November 25, 2020

**Re: CPF No. 3-2020-1009M
Notice of Amendment
Tallgrass Energy Partners, LP**

Figure 5: Non-Automated Mainline Valve Faceplate Notification

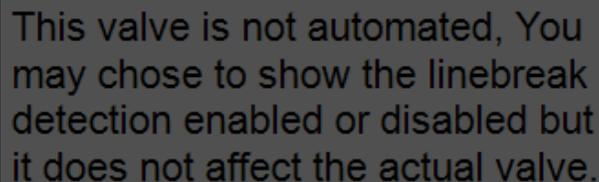
As part of this item, PHMSA indicated that Tallgrass's O&M Procedure OM1100_GL was deficient because it provided that the referenced API RP 1165 sections would be implemented when "adding, expanding, or replacing displays", and that the Natural Gas SCADA HMI Standards document referenced in Section 5 of OM1100_GL did not provide sufficient additional guidance on what types of changes would constitute additions, expansions or replacements to the SCADA system. Moreover, PHMSA stated that the Natural Gas SCADA HMI Standards document inadequately implemented Sections 4 and 8.3 of API RP 1165 by not providing sufficient details to define symbols, font size, and other attributes of the standard symbol library. Finally, PHMSA stated that Tallgrass's SCADA display did not show units for temperature, pressure or flow, and that symbols did not differentiate manual and remote-control operation of a valve.

Although PHMSA notes in the NOA that Tallgrass uses a “Trailblazer MLV 1.2.4 system, by way of clarification, Tallgrass in fact does not have an MLV 1.2.4 on the Trailblazer system. Rather, the Trailblazer system consists of 24 mainline valves labeled MLV001-MLV024. These valves are not controlled by the Lakewood OCC, and controllers located within cannot issue an open or close command for them. Controllers in the Lakewood OCC can, however, see the status of these valves at all times. This limitation is clearly noted on all Trailblazer mainline valve faceplates, as shown in Figure 5:

This valve is not automated, You may chose to show the linebreak detection enabled or disabled but it does not affect the actual valve.
